Date:	November 4, 2019
To:	Beth Callahan, Project Manager, Maine Department of Environmental Protection
	Karem Gungor, Environmental Engineer, Maine Department of Environmental Protection
From:	Elizabeth M. Ransom, P.G. Ransom Consulting, Inc.
Subject:	Nordic Aquafarms, Inc., Land-based Aquaculture Facility, Belfast, Maine L-28319-26-A-N, Review Comments
Project No.:	171.05027

This memo provides responses to the Technical Review Memorandum from Karem Gungor to Beth Callahan dated October 3, 2019. For clarity, the entire comment from the technical memorandum has been copied below and italicized. Responses are in regular text, and on the attached plans and figures as referenced below.

PROJECT MANAGER:	ADB	PROJECT NO:	18076
A/E OF RECORD:			
JOB CAPTAIN:	SP		
DRAWN BY:	AJ		
SMRT FILE:	CE111-18076	SHEET No.	CE111

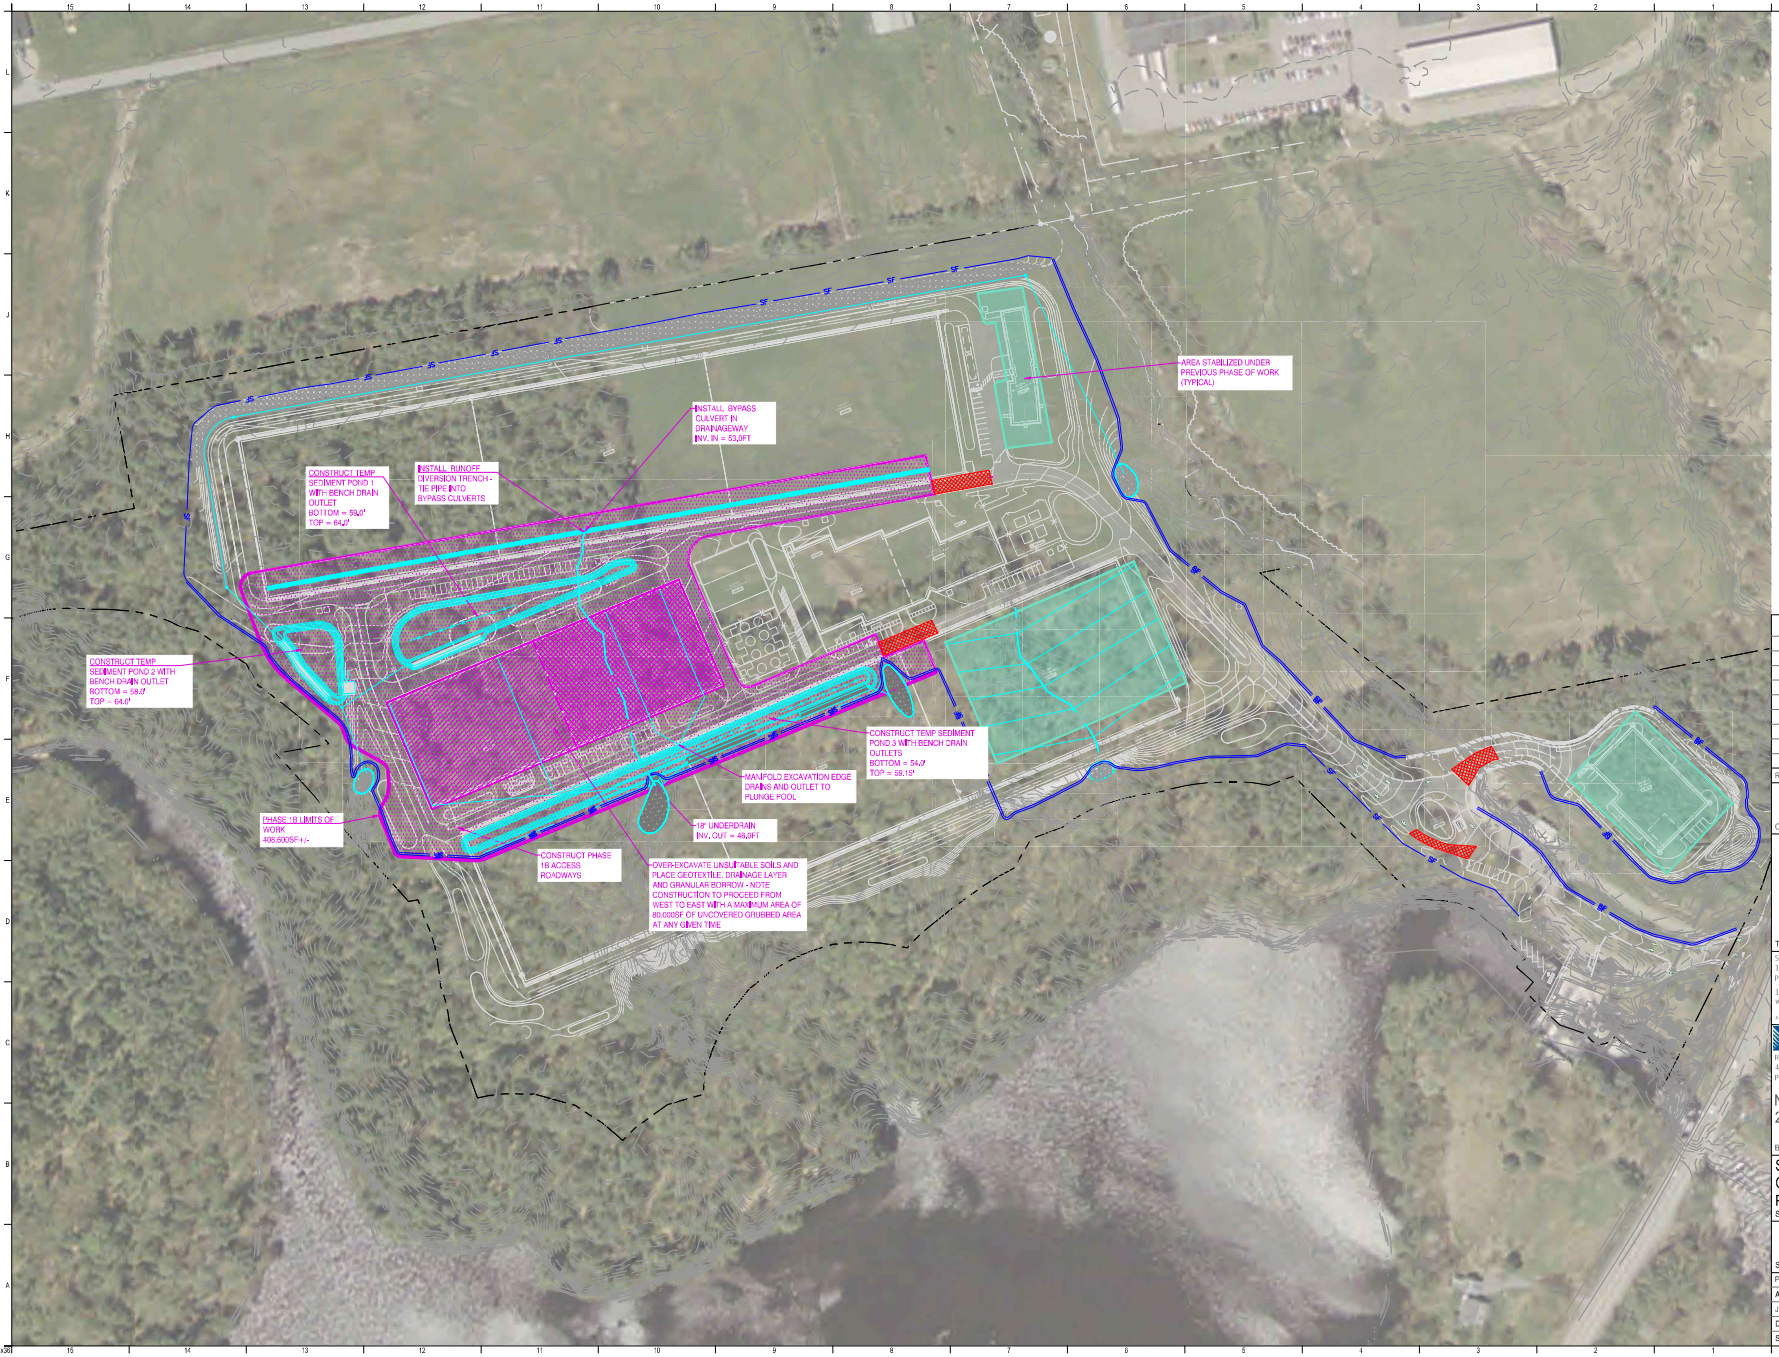
1. First Diversion Trench (Sheet CElll): This trench will not be connected to the edge drain/culvert bypass system as shown in the ESC phasing plans. The trench will intercept the surface runoff from approximately 8.5 acres of upgradient area (see south of Subcatchment 9 flow path in Sheet CW-102) which appears to shed into the streams S3, SS, and S6 under the existing/pre-development conditions. The intercepted flow (surface runoff+ groundwater) will be discharged into an easterly plunge pool based on the underdrain invert elevations provided in Sheet CElll. I recommend the following:

a. Connect the trench underdrain to a bypass culvert or bypass culverts so that the intercepted flow is conveyed southerly and contributes to the baseflow provided for the streams S3, S5, and S6 under the post-development condition,

b. Eliminate the westerly and easterly outfalls of the trench underdrain shown in Sheet CE118. The outfalls may be necessary during the initial phases of the project; but they need to be removed or

deactivated post construction to simulate the pre-development site hydrology to the extent practicable and mitigating the project's hydrologic impact on the jurisdictional streams,

2. Second Diversion Trench (Sheet CE112): Since this trench will be below the finished floor elevation of Building 1, will it have a minimum crushed stone reservoir depth of 6 ft as shown in Detail ESC-7 in Sheet CE502? A separate detail drawing for this trench is requested.

1a. A new extended bypass drain has been added to the plans during Phase 2A of the project. The Phase 1 outlets will be eliminated, and the new drain system will convey flows around the site to discharge at Streams S3, S5, and S6, as requested.

During the initial installation, the second diversion trench will be exactly the same as the first, with a crushed stone reservoir to divert groundwater from the surrounding area into the diversion culvert that outlets in a southerly direction to the project limits. The same detail will apply to both trenches (Detail ESC-7 on Sheet CE502). As the excavation and backfill proceeds, the trench will be buried in the backfill section.
